CITY OF MADISON
CITY ENGINEERING DIVISION
DEPARTMENT OF PUBLIC WORKS
PLAN OF PROPOSED IMPROVEMENT

CAPITAL CITY TRAIL BOX
CULVERT REPLACEMENT
CITY PROJECT NO. 15271
CONTRACT NO. 9591

ADDENDUM #1: 5/20/2025; REVISED THE FOLLOWING: PM1-PM4
REVISION #1: 8/6/2025; REVISED SHEETS: U1, U3-U6
REVISION #2: 9/23/2025; REVISED SHEETS: U1, U2, U5, U6
REVISION #3: 9/26/2025; REVISED SHEETS: U1, U5, E1 - SHEETS ADDED: E2
REVISION #4: 10/8/2025 REVISED SHEETS: U1, U3-U5

15271 U-1

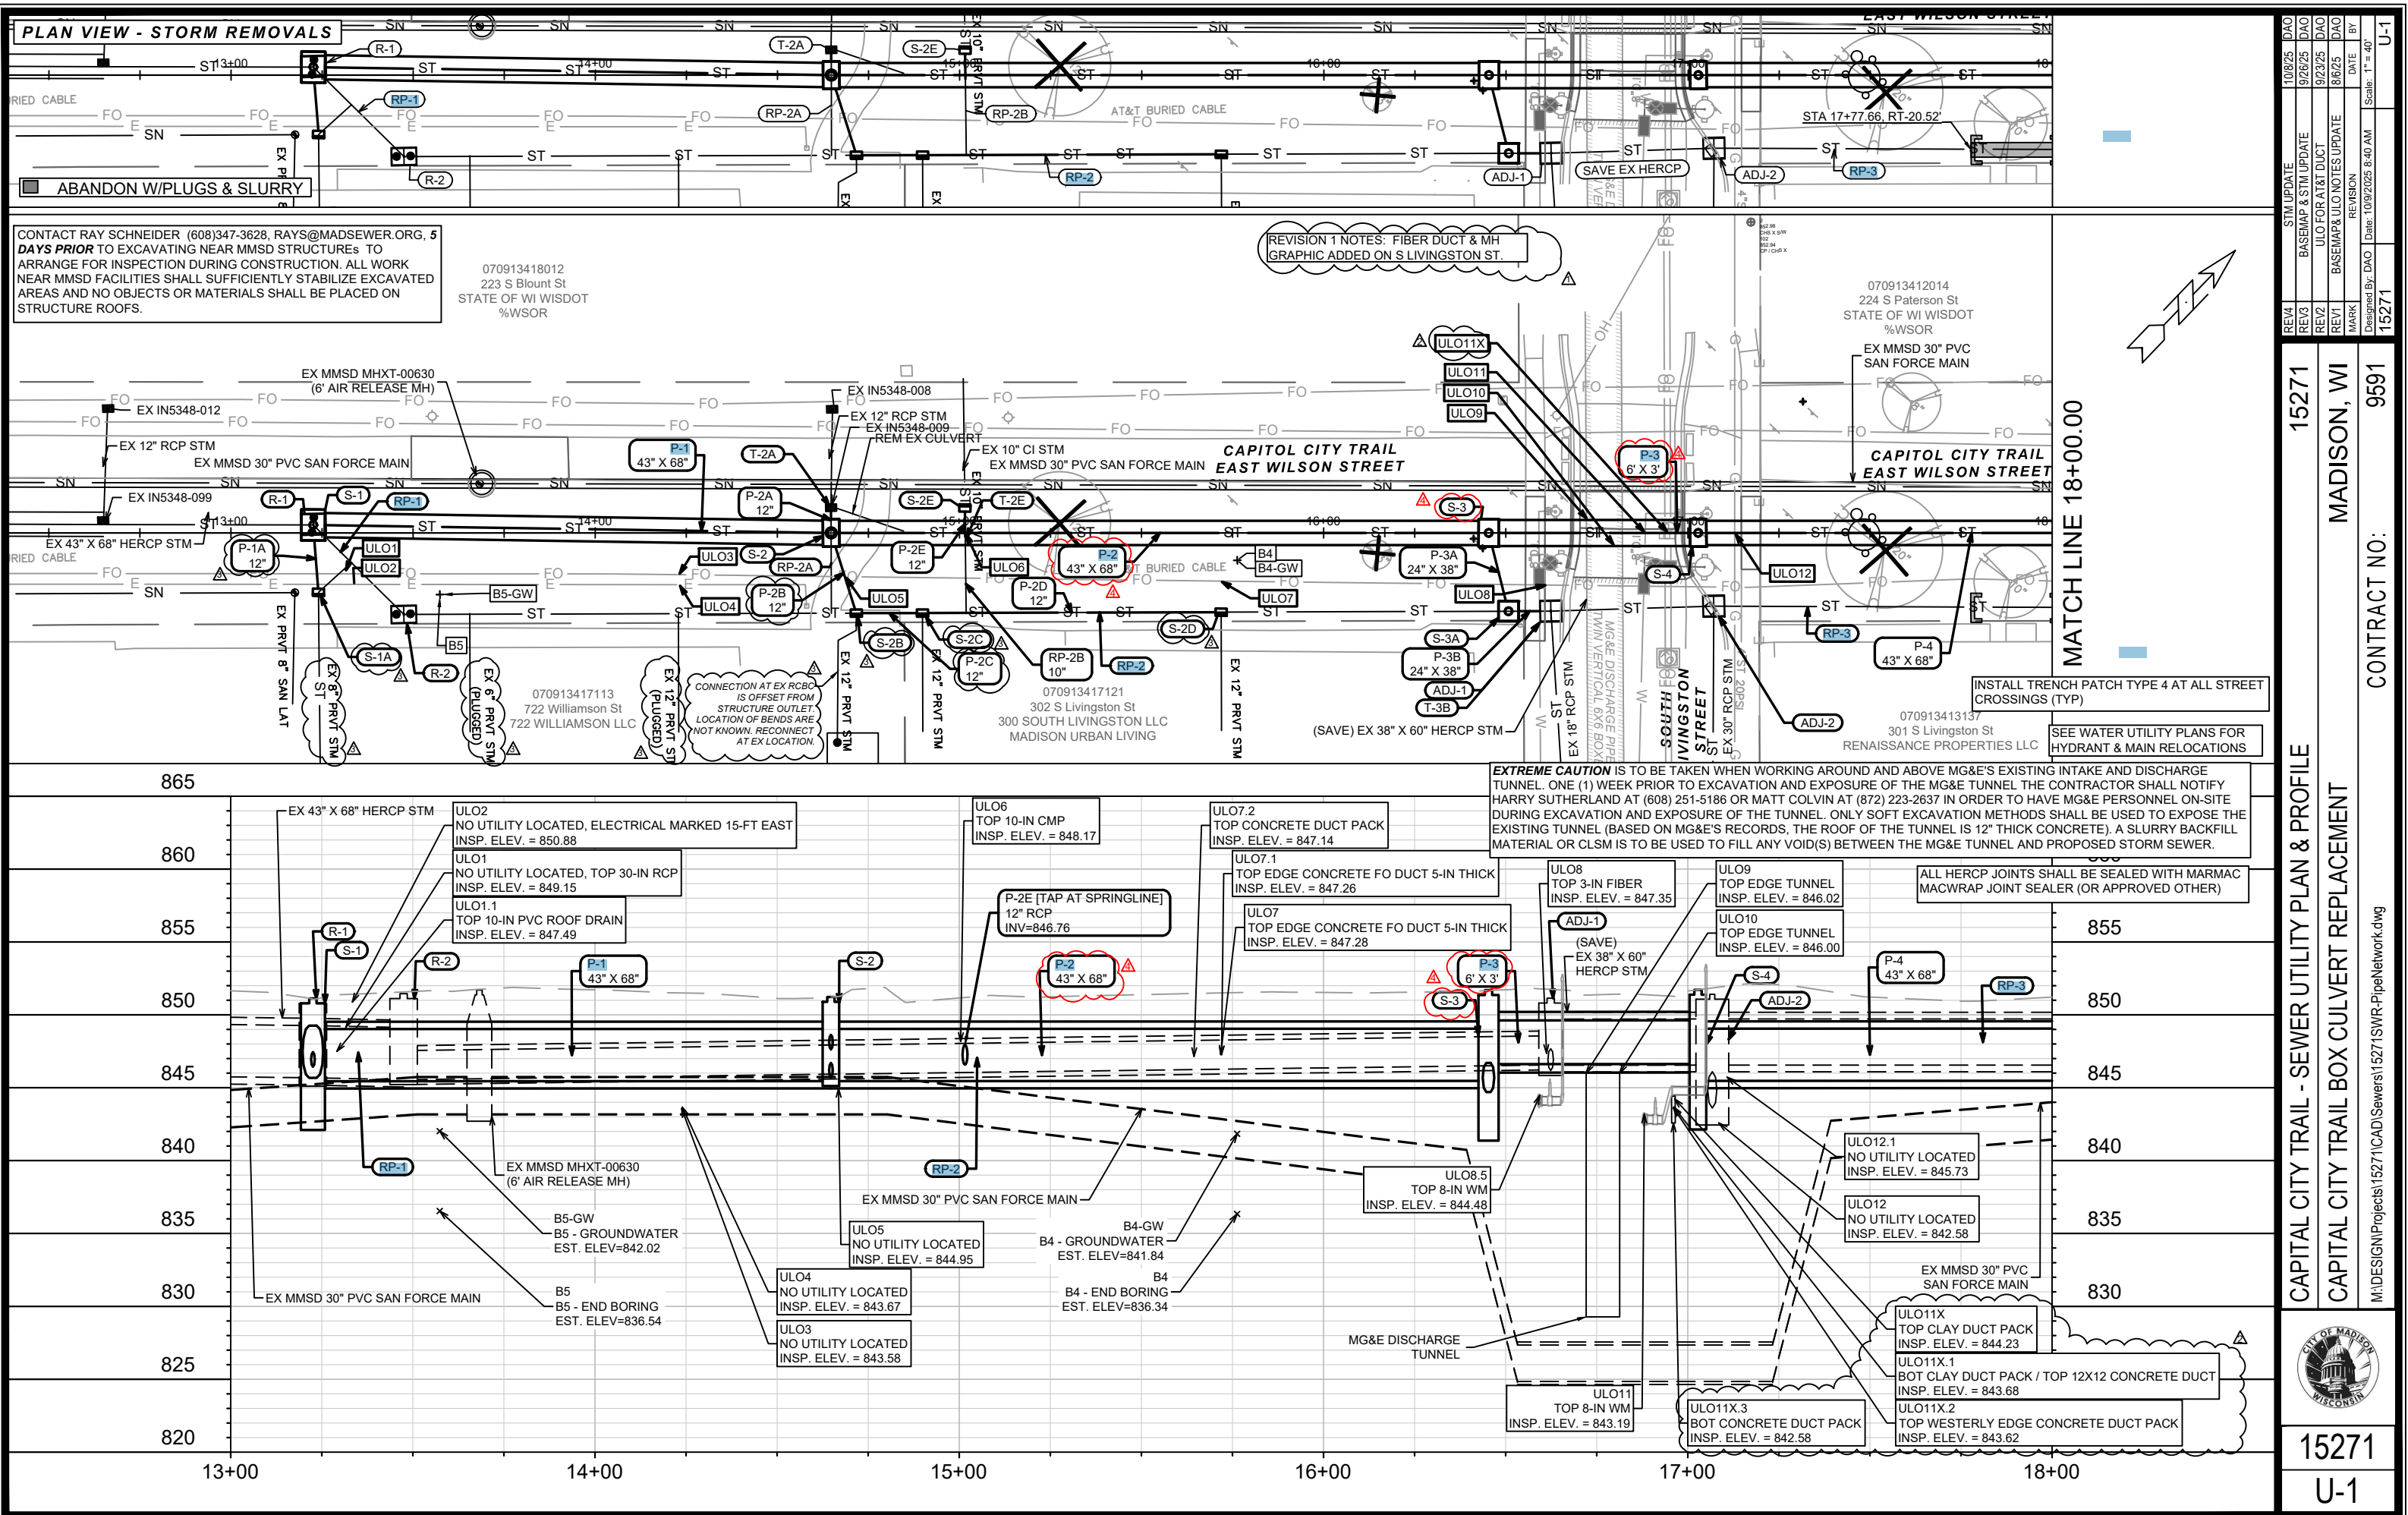
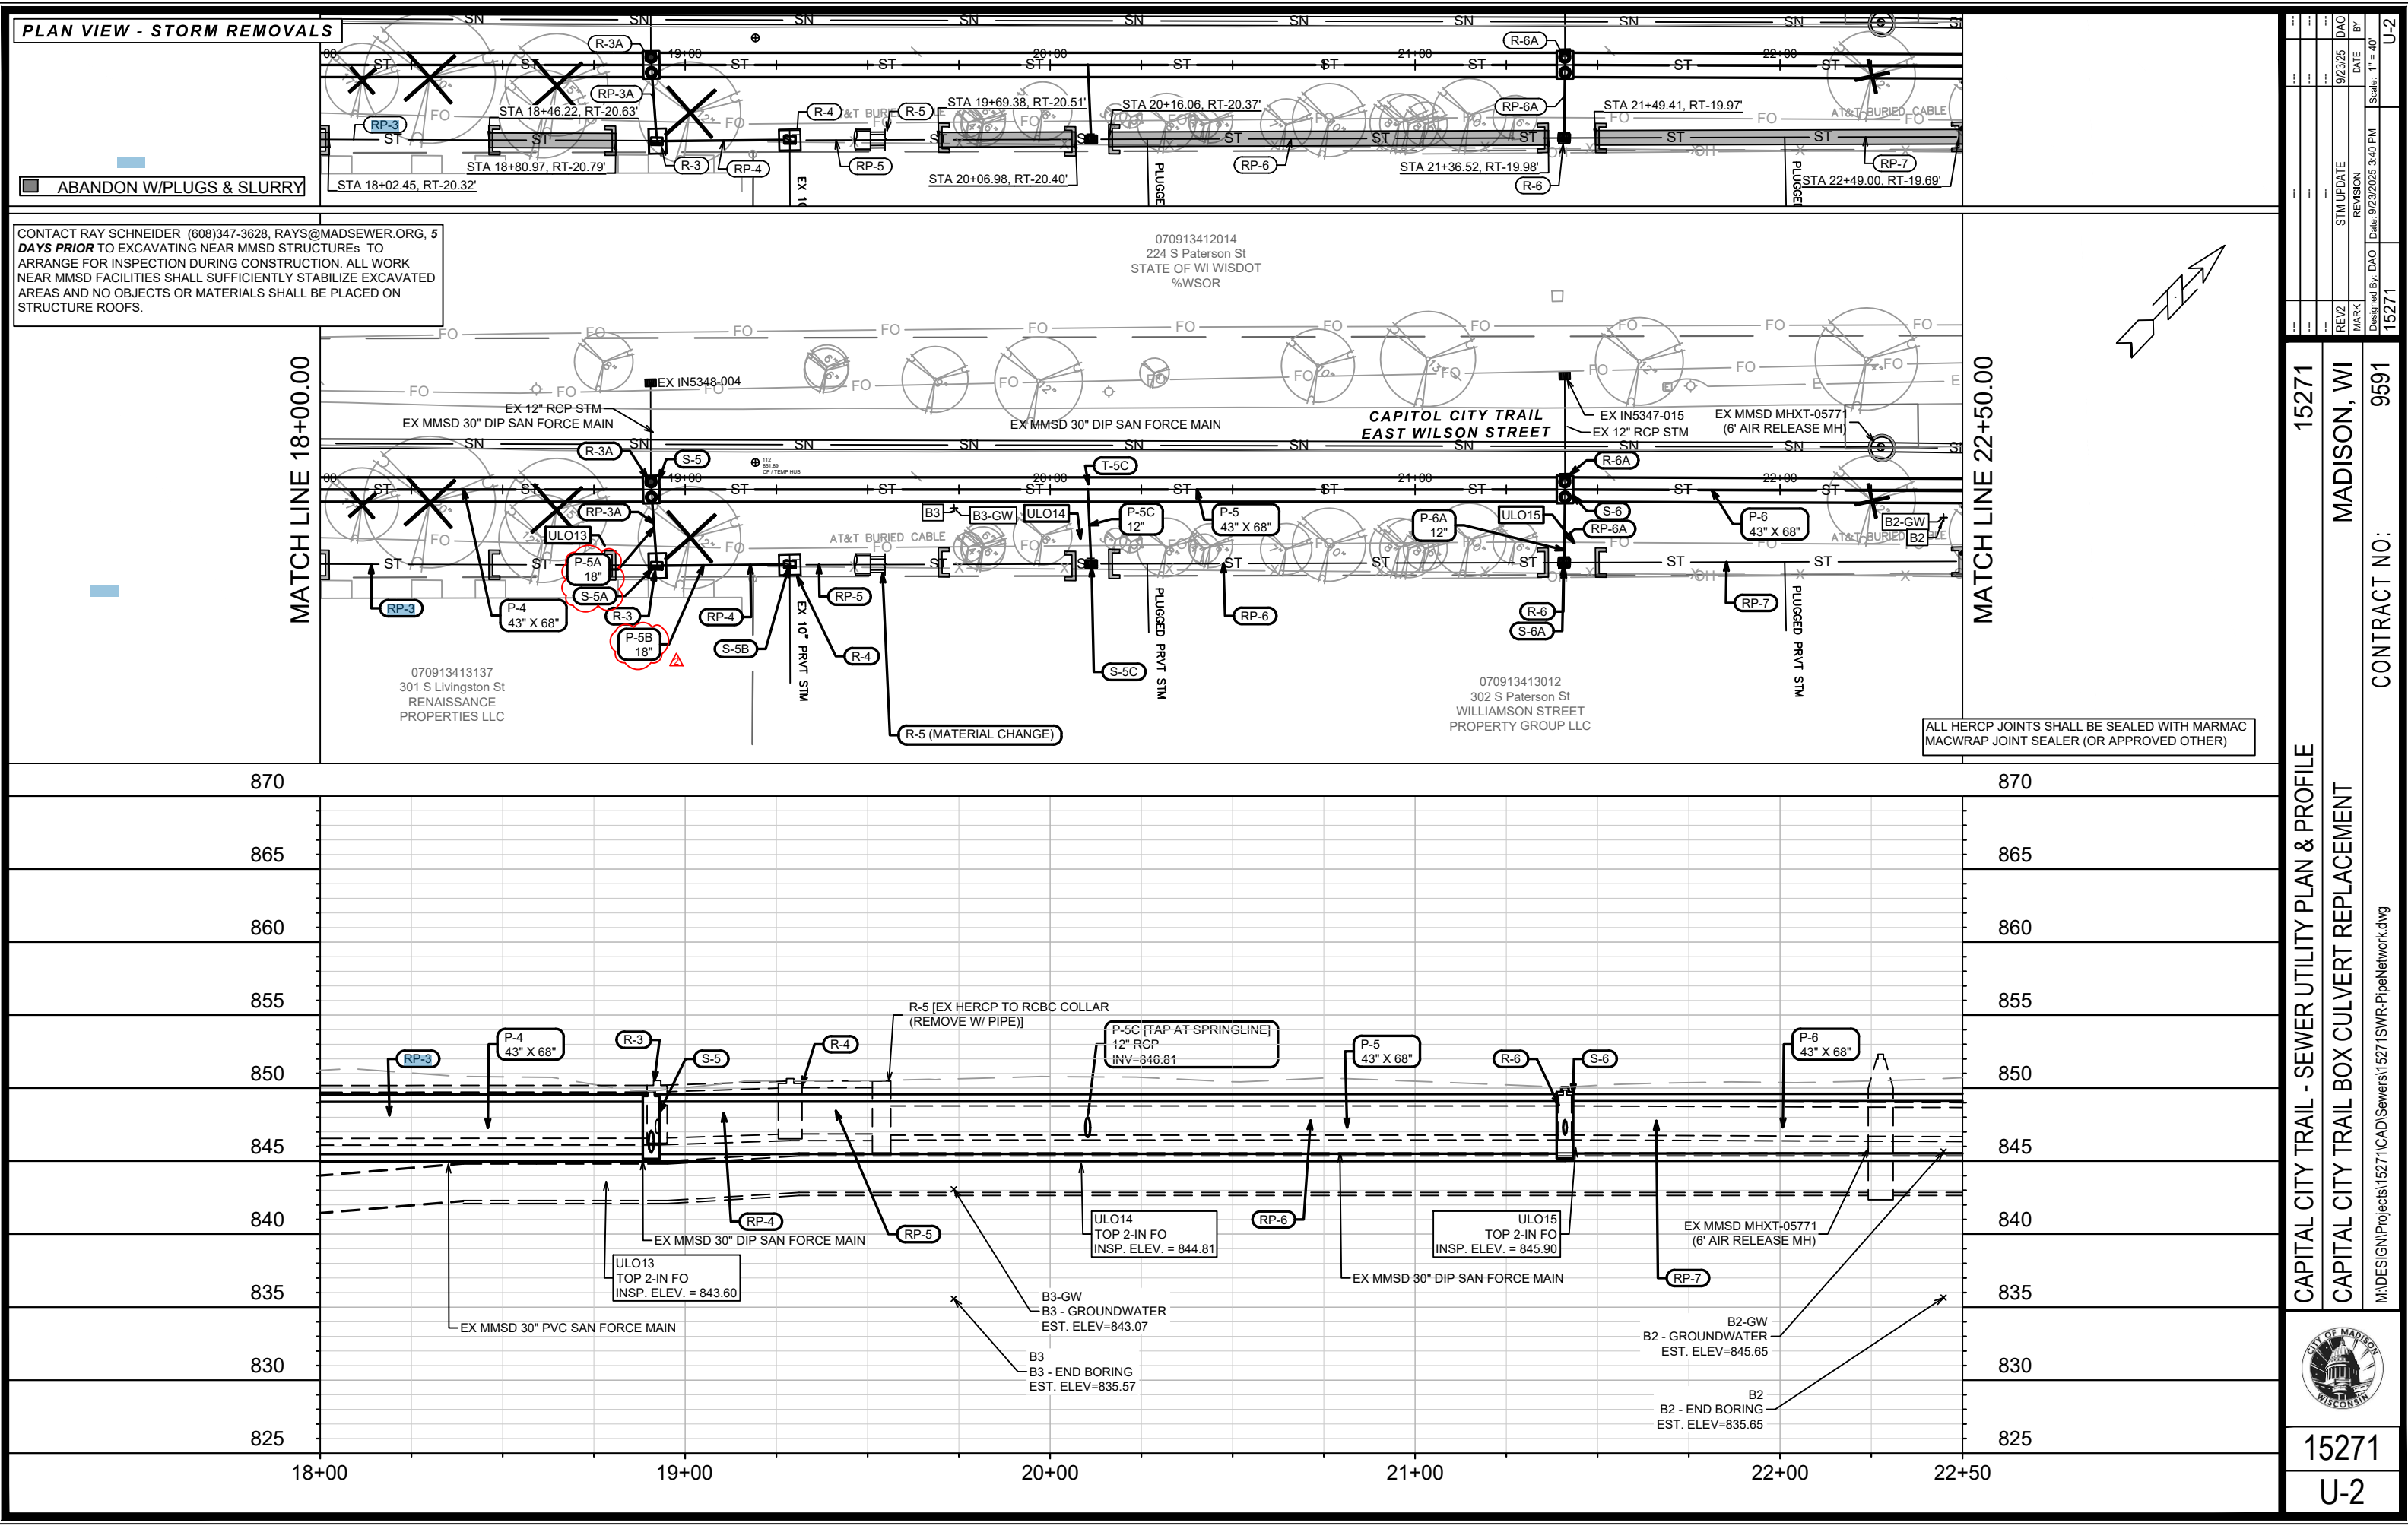
MARK	REVISION	DATE	BY
REV1	BASEMAP & ULO NOTES UPDATE	8/6/25	DAO
REV2	ULO FOR AT&T DUCT	9/23/25	DAO
REV3	BASEMAP & STM UPDATE	9/26/25	DAO
REV4	STM UPDATE	10/8/25	DAO

REVISION 1 NOTES: EX SAN SAS NAME
UPDATED, MGE DUCT GRAPHIC & WATER MAIN
CASING GRAPHIC ADJUSTED TO SURVEYED
LOCATIONS. FIBER DUCT GRAPHIC ADDED.
